National Transportation Safety Board

Safety Recommendation

Date: December 12, 2000

In reply refer to: A-00-121 through -124

Figure 1. Cross-section of a GE CF6-802 engine and enlarged view of the HPT module

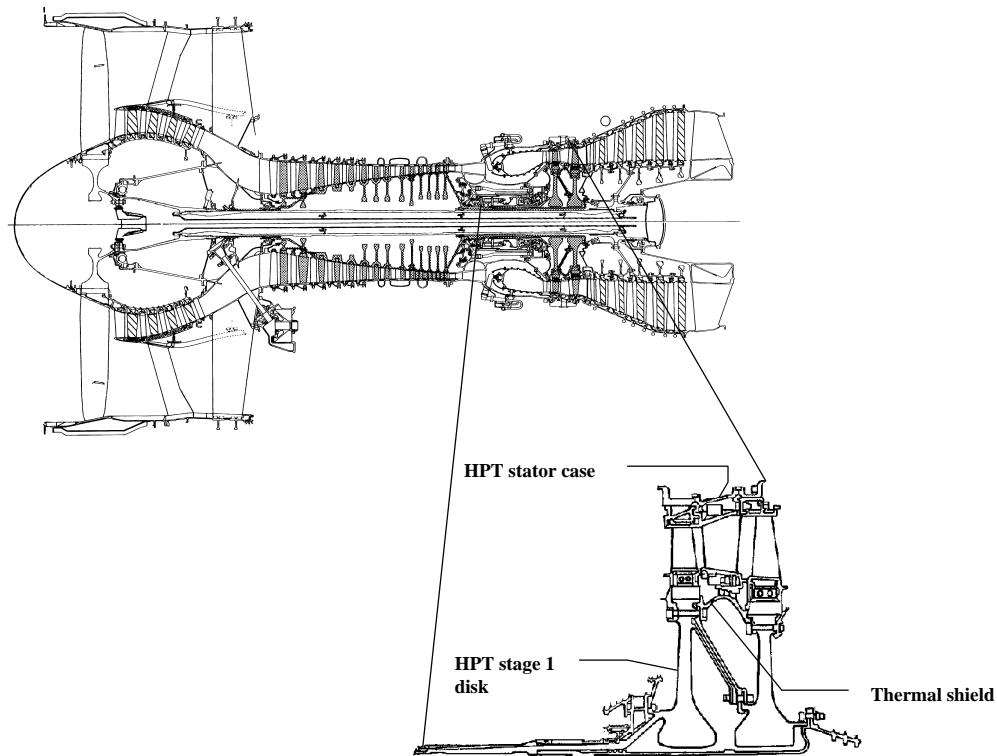
In this letter, the National Transportation Safety Board recommends that the Federal Aviation Administration (FAA) take action to address safety issues that were identified during its investigation of an uncontained engine failure¹ that occurred at Philadelphia, Pennsylvania, on September 22, 2000, as a result of cracking and rupture of a high pressure turbine (HPT) stage 1 disk² in a General Electric (GE) CF6-80C2B2 engine (see figure 1).
